ATA Security feature Set Clarifications

To: T13 Technical Committee
From: Jim Hatfield
Seagate Technology
(with Jeff Wolford: Hewlett-Packard)
389 Disc Drive
Longmont, CO 80503
Phone: 720-684-2120
Fax: 720-684-2722
Email: James.C.Hatfield@seagate.com
Date: March 31, 2006

I propose that the following text be incorporated into ATA/ATAPI-8 ACS [as a full replacement for the referenced sections.](#)

Figure 1 - Security State Mode Diagram

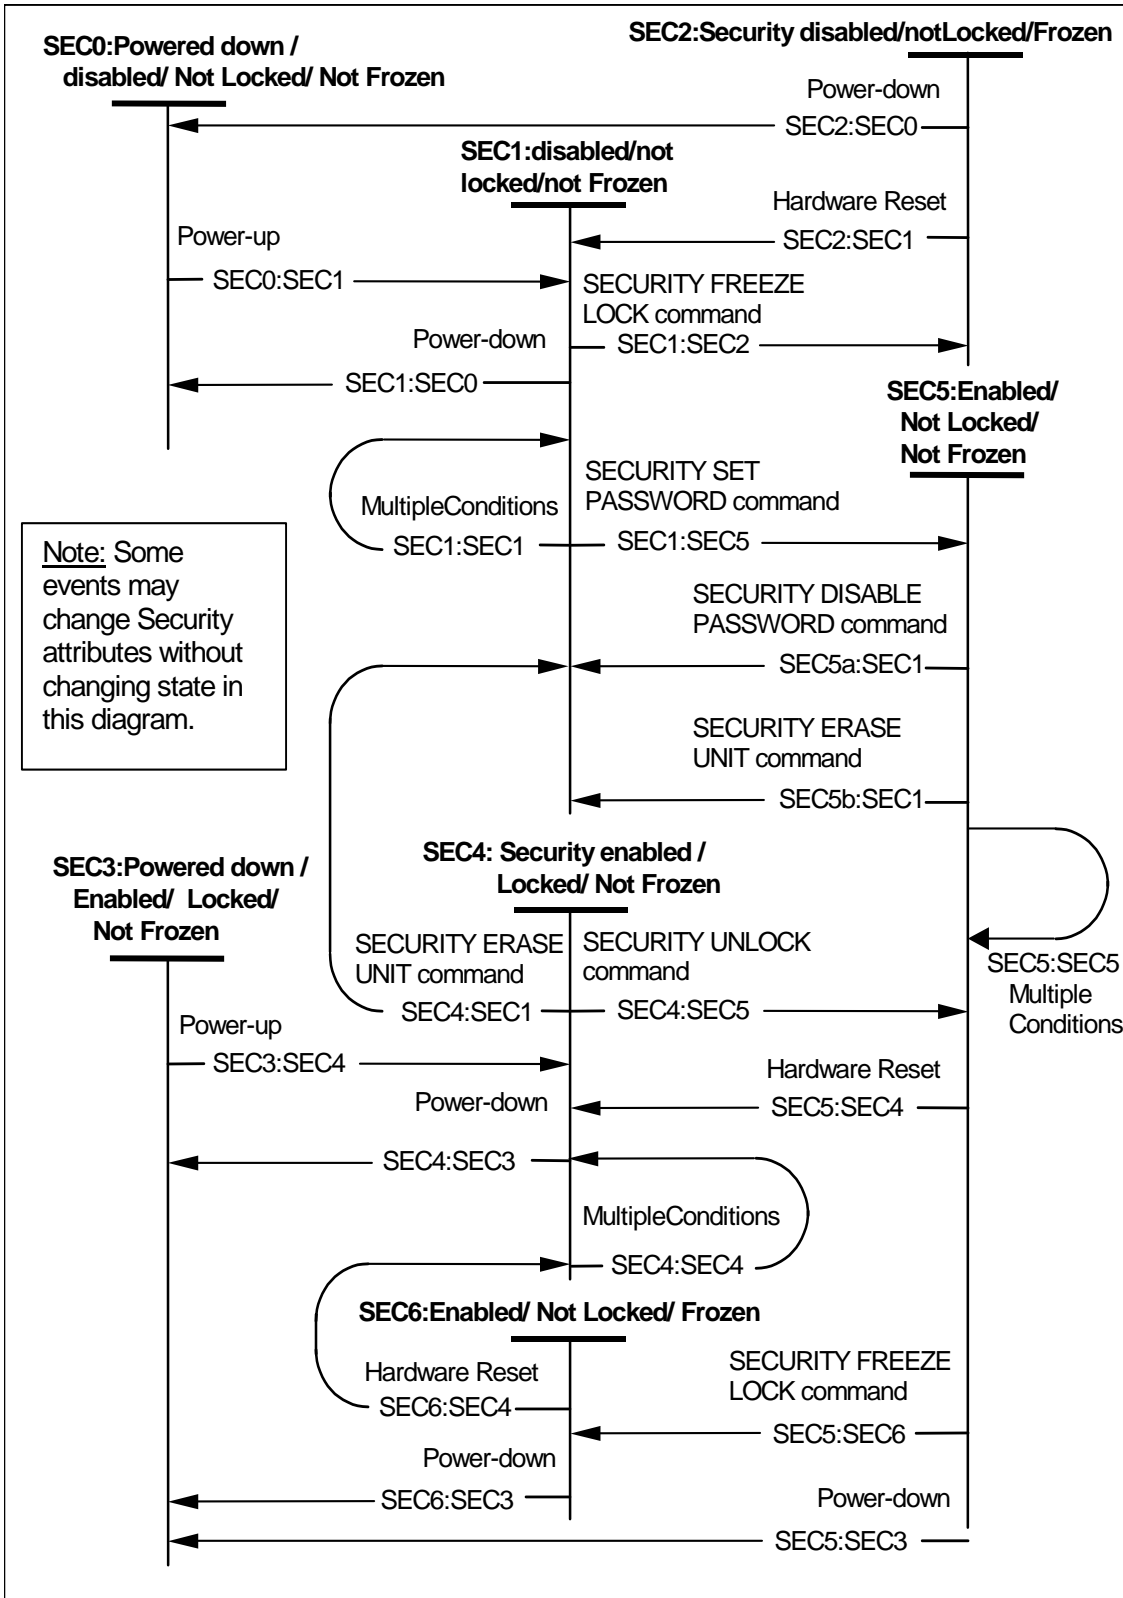
State SEC0: Powered down/Security Disabled/Not Locked/ Not Frozen: This ~~mode~~state shall be entered when the device is powered-down with the Security ~~Mode~~ feature set disabled.

Transition SEC0:SEC1: When the device is powered-up, the device shall make a transition to the SEC1: Security disabled/not Frozen state, ~~and initialize the IDENTIFY DEVICE or IDENTIFY PACKET DEVICE data.~~

State SEC1: Security Disabled/Not Locked/ Not Frozen: This ~~mode~~state shall be entered when the device is powered-up or a hardware reset is received with the Security ~~Mode~~ feature set disabled or when the Security ~~Mode~~ feature set is disabled by a SECURITY DISABLE PASSWORD or SECURITY ERASE UNIT command.

Transition SEC1:SEC1: When a Hardware reset occurs the device shall remain in state SEC1.

[Editors note: do we need this loopback ? what about non-security commands ? is this list of events inclusive or exclusive ?]

[Editors note: if the loopback is kept, should it be labeled ?]

Transition SEC1:SEC2: When a SECURITY FREEZE LOCK command is ~~received~~ successful, the device shall make a transition to the SEC2:~~Security disabled/Frozen~~ state.

Transition SEC1:SEC5: When a SECURITY SET (user) PASSWORD command is ~~received~~ successful, the device shall save the User password, update the Security Level and make a transition to the SEC5:~~Unlocked/not frozen~~ state.

Transition SEC4:SEC1: [When a SECURITY ERASE PREPARE command is successful and is followed by a successfully completing SECURITY ERASE UNIT command, the device shall make a transition to the SEC1 state.](#)

Transition SEC4:SEC4: When the device receives a hardware reset, the device shall [remain in](#) state SEC4. ~~[Editor’s note: Only transitions which change state are shown.]~~
[\[Editors note: do we need this loopback ? what about non-security commands ? is this list of events inclusive or exclusive ? \]](#)

Transition SEC4:SEC5: When a ~~successful~~ SECURITY UNLOCK command is ~~received~~ successful, the device shall make a transition to the SEC5: ~~UNLOCKED/NOT FROZEN~~ state.

Transition SEC5:SEC1: When a ~~valid~~ SECURITY DISABLE PASSWORD command is successful ~~received~~, the device shall make a transition to the SEC1: ~~Security disabled/not Frozen~~ state.

~~**Transition SEC5:SEC6:** When a SECURITY FREEZE LOCK command is successful received, the device shall make a transition to the SEC6: Unlocked/Frozen state.~~

Transition SEC5:SEC6: When a SECURITY FREEZE LOCK command is successful, the device shall make a transition to the SEC6 state.

State SEC6: Security Enabled/ Locked/ Frozen~~Unlocked/ Frozen~~: This ~~mode~~state shall be entered when the device receives a SECURITY FREEZE LOCK command while SEC5:~~UNLOCKED/NOT FROZEN: Unlocked/Locked~~state.

Transition SEC6:SEC4: When the device receives a hardware reset, the device shall make a transition to the SEC4:~~Security enabled/Locked~~ state. ~~[Editor’s note: Frozen state is only exited after a power-on reset. This is a bug that has persisted and was never discovered before.]~~
